Rezoning Transportation Analysis
Petition Number: Insert Zoning Petition #2021-209
General Location Identifier: 20109103

Revision Log:

Transportation Summary

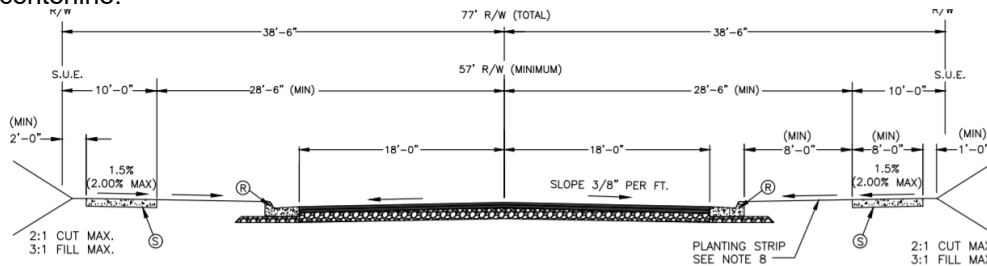
1. ~~**Curb line:** The proposed zoning district has a setback measured from back of the existing or proposed future curb line.~~
 - a. ~~**Steele Creek Road:** Curb and gutter will be constructed in accordance with the typical section established in the U-5766 STIP Project, as generally depicted on the site plan. Rescinded after 03/10/2022 Coordination with petitioner and NCDOT.~~

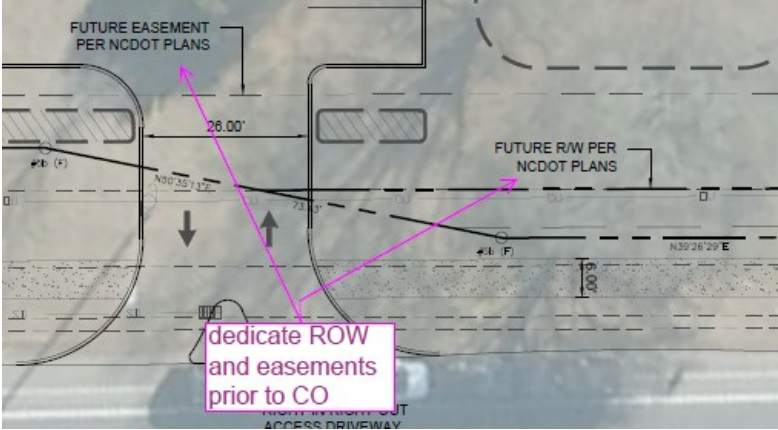
- b. ~~**Rigsby Road:** Curb and gutter will be constructed in accordance with CLDSM U-05A, Local Commercial Wide cross section with the back-of-curb located 20.5 feet from the existing centerline.~~

Label and dimension the back of curb and gutter from the existing centerline of each road.

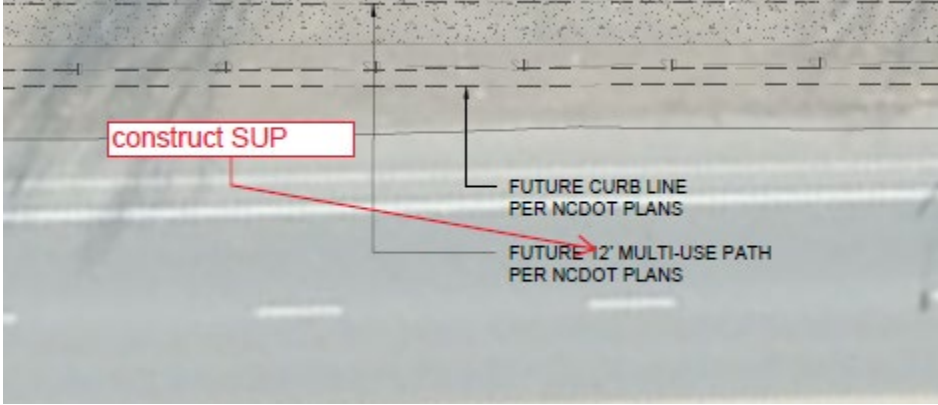
- a. **Steele Creek Road:** ~~Revise site plan and conditional note(s) to commit to dedicate the right-of-way and easements, in accordance with the typical section established in the U-5766 STIP Project, as generally depicted as on the site plan.~~

- b. **Rigsby Road:** ~~Revise the site plan and conditional notes to dedicate 38.5 feet of right-of-way, in accordance with CLDSM U-05A Local Commercial Wide cross section, from the existing road centerline.~~

Outstanding Comment: ~~The site plan shall label and dimension the right-of-way from each road centerline.~~

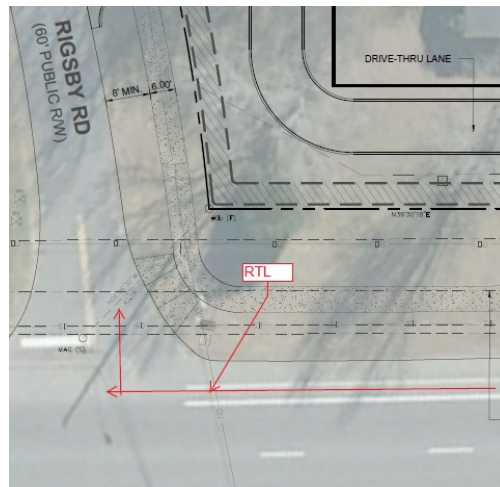
6. ~~Revise site plan by removing the proposed right in right out driveway on Steele Creek Road.~~

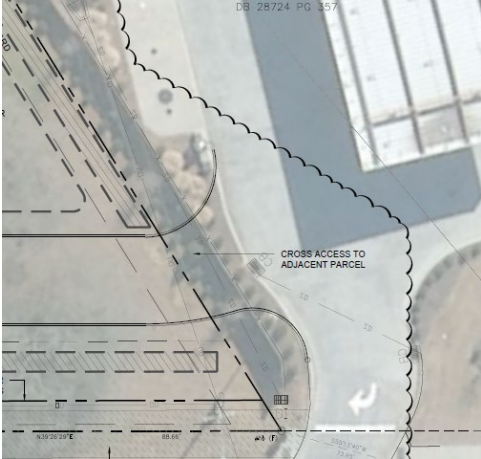
- 12. ~~New Comment as a Result of 03-14-2022 Site Plan: Revise the conditional notes by committing to provide an access easement, during permitting, with PID 20109114 to allow cross-access as generally shown on the site plan.~~

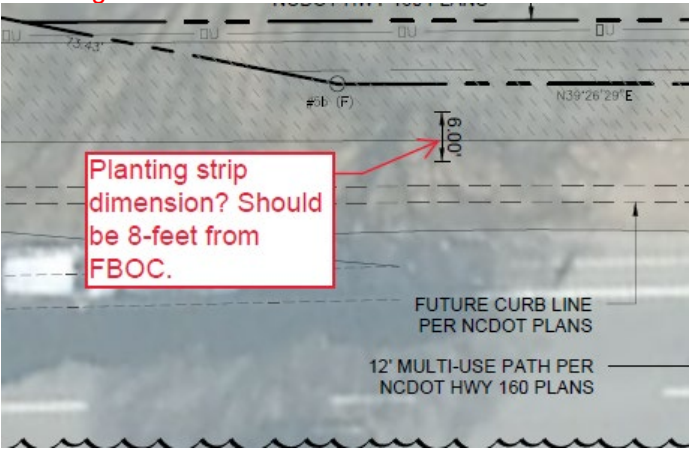
- 13. ~~New Comment as a Result of 03-14-2022 Site Plan: Revise the site plan by clarifying the 6-foot dimension on the site's frontage of Steele Creek Road.~~
